CERTIFICATE OF APPROPRIATENESS

Property: 536 Harvard Street, Lot 21, Block 289, Houston Heights Subdivision. The property includes a two-story historic 2,808 square foot former fourplex apartment building and a detached rear garage situated on a 6,600 square foot (50' x 132') interior lot. The previous owner converted the fourplex into a single-family residence.

Proposal: Alteration-Revision. The application was deferred at the July 2016 HAHC meeting so that staff could inspect the porch alterations and the applicant could request quotes of returning the porch to its original state.

WEST ELEVATION – FRONT FACING HARVARD STREET

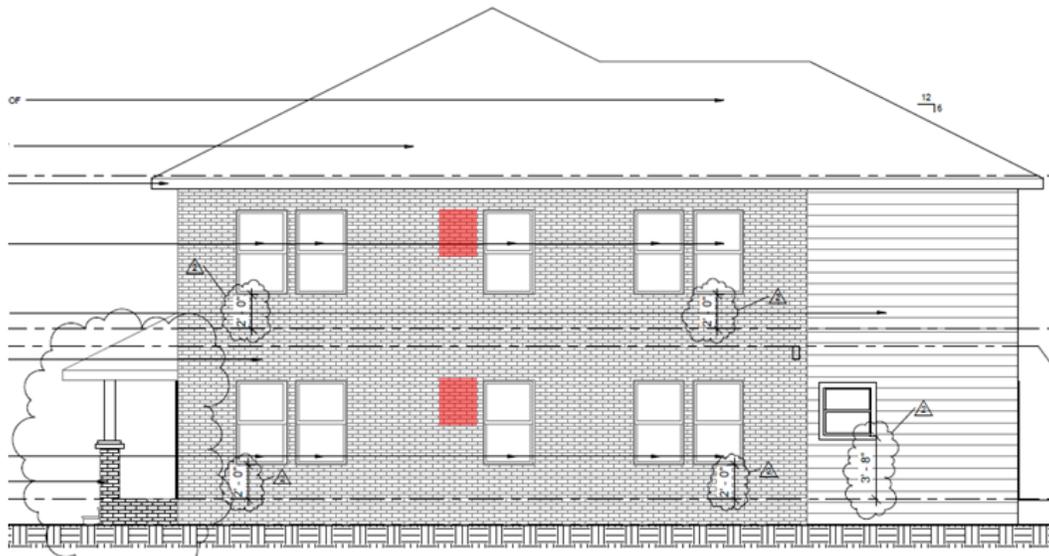
The partial brick encasement of the original full length columns, removal and replacement of the original front door, installation of slate tile on the porch and steps, removal of original windows and bricking in window openings, and limewashing the original brick veneer does not preserve the historical character of the property since it will attempt to remove the ghosting of the original window openings which would further diminish the historic character of the building by eliminating any trace of the original fenestration pattern, damage the original historic material, and altering the historic appearance of the building. |

Partial encasement in brick

Replaced Front Door

HAHC Action: COA Denied. Certificate of Remediation granted for the replacement of the existing front door with a salvaged front door to match the original 12-lite design, the removal of the partial brick encasement on the front porch columns, and installation of 9-lite windows in the auxiliary door openings (as previously approved). Removed and bricked-in side windows may remain and slate on the porch may remain.

PROPOSED DOOR OPTIONS

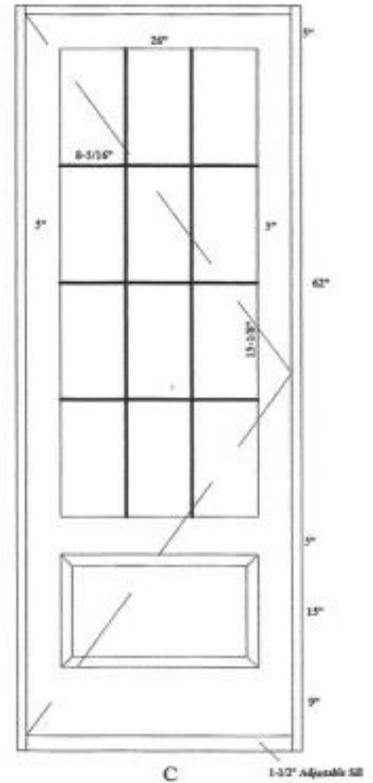
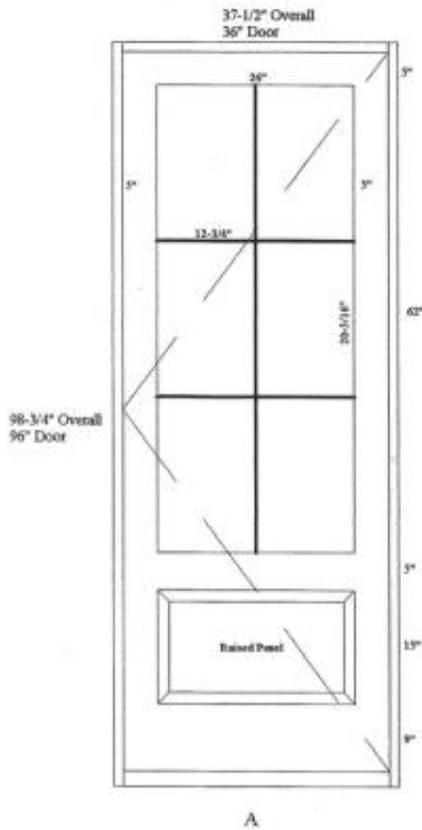
- 1. Replace the new inappropriate front door (the original 12-lite front door was disposed of despite previous HAHC ruling that it remain) with a new wood 6-lite or 12-lite wood door to better simulate the original door.
2. Replace the inappropriate frosted fixed pane windows in the auxiliary door openings with 9-lite wood windows (as approved in August 2014).

FIRST FLOOR PLAN

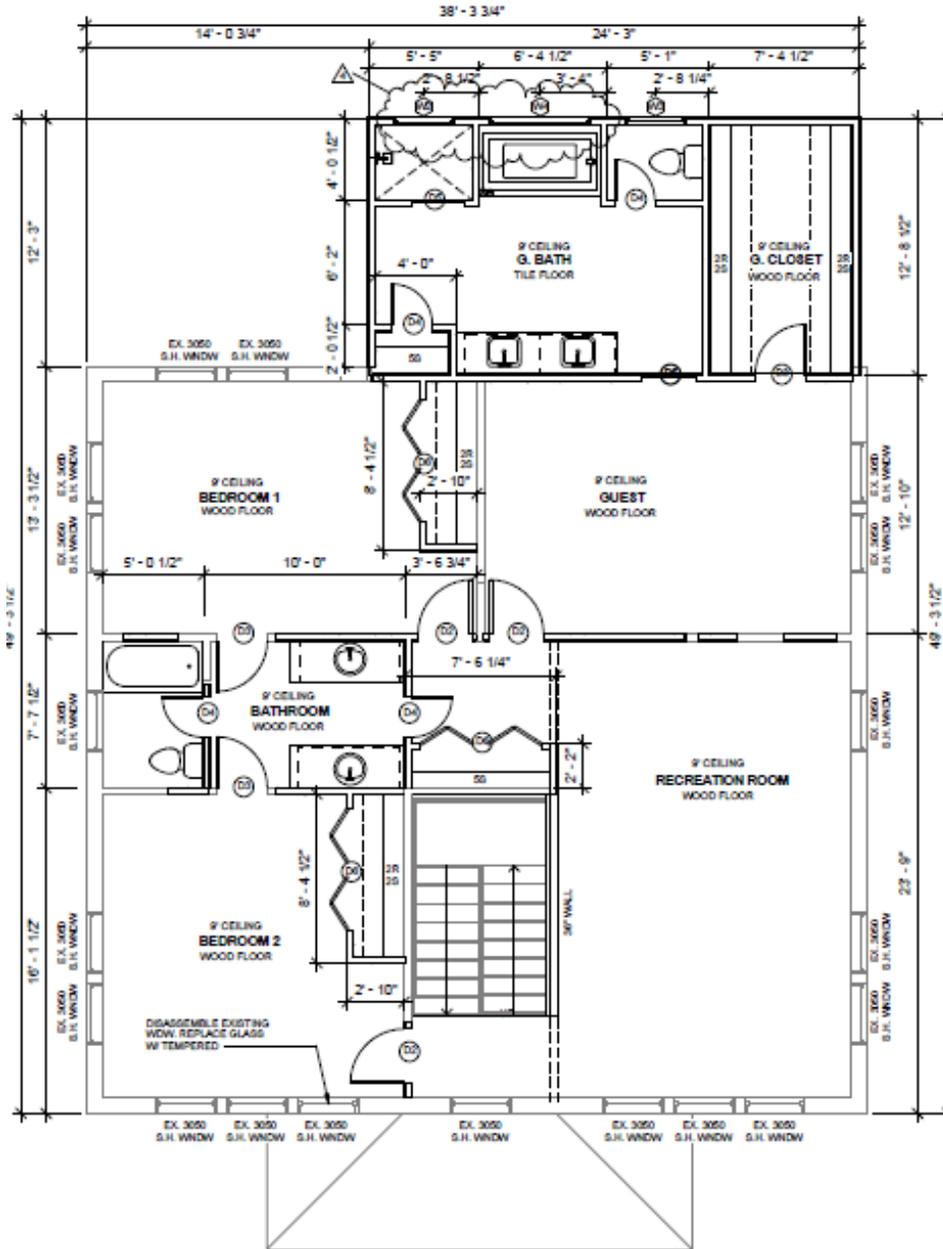
Windows/Doors: March 2016: The previous owner/applicant requested approval for inappropriate alterations that exceeded the approved scope of work. On the north elevation, a pair of windows and a single window on the first story were removed and the openings bricked in. Two rows of glass block were installed above the bricked in paired window location. A single window on the second story was also removed and the window bricked in. On the south elevation, a single window on both stories was removed and bricked in. The windows were destroyed. These window alterations did not appear as part of the application and were not indicated on the drawings. The original front door was removed, despite the HAHC condition that the original door was to remain. The auxiliary front doors were to be replaced with fixed 9-lite wood windows. The installed windows are instead fixed single pane. The March 2016 scope of work was Denied by the HAHC.
